Access Compliance Report

Public Rights-of-Way

(Curb Ramps)

Intersection ID: 27708	Main Street: BREM_LN	Cross Street: LEDERER_AV	Location: NW
ADA ID: C08BBDBC3862	Ramp Type: Perp	Initial Pass/Fail: Fail	Overall Compliance: No
Severity Score: 25			
Codes/Mitigation Info/Possible Solution		Field Measurements/Component Compliance

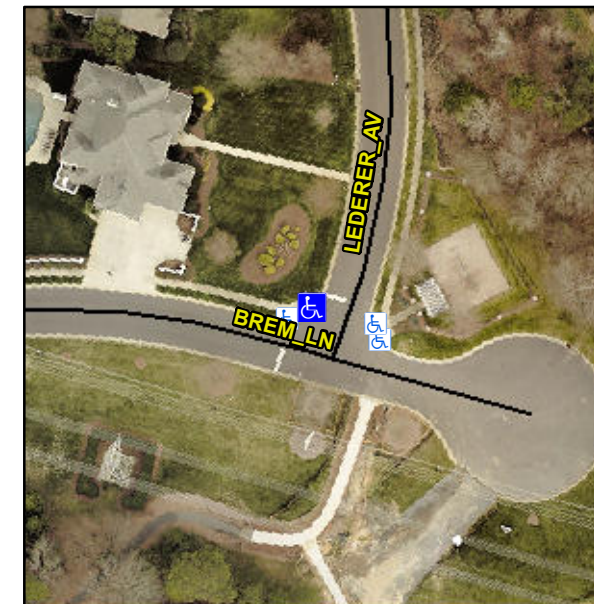
Not Found, R304.5.3

Compliance	Description	Data	Compliance	Description	Data
N/A	Ramp Length (in)	46.0	Yes	Ramp Slope (%)	5.1
Yes	Ramp Width (in)	48.0	No	Ramp XSlope (%)	8.5
N/A	Flare Type LT	N/A	N/A	Flare Type RT	N/A
N/A	Flare Slope LT (%)	N/A	N/A	Flare Slope RT (%)	N/A
N/A	Flare Traversable LT?	N/A	N/A	Flare Traversable RT?	N/A
N/A	Landing Length (in)	N/A	N/A	DWS Provided?	N/A
N/A	Landing Width (in)	N/A	N/A	DWS Contrast?	N/A
N/A	Landing Slope (%)	N/A	N/A	DWS Length (in)	N/A
N/A	Landing X Slope (%)	N/A	N/A	DWS Full Width?	N/A
N/A	Landing Curb? (Y/N)	N/A	N/A	DWS Offset (in)	N/A
N/A	Shared Landing?	N/A			
N/A	Gutter Ponding?	N/A	N/A	Gutter Slope (%)	N/A
N/A	Gutter Lip Ht (in)	N/A	N/A	Gutter X Slope (%)	N/A
N/A	Painted X Walk1?	No	N/A	Painted X Walk2?	N/A
	X Walk 1 Direction	To SE		X Walk 2 Direction	N/A
N/A	X Walk 1 Width (in)	N/A	N/A	X Walk 2 Width (in)	N/A
	X Walk 1 Slope (%)	3.4		X Walk 2 Slope (%)	N/A
	X Walk 1 X Slope (%)	7.5		X Walk 2 X Slope (%)	N/A

Remove & Replace Entire Ramp.
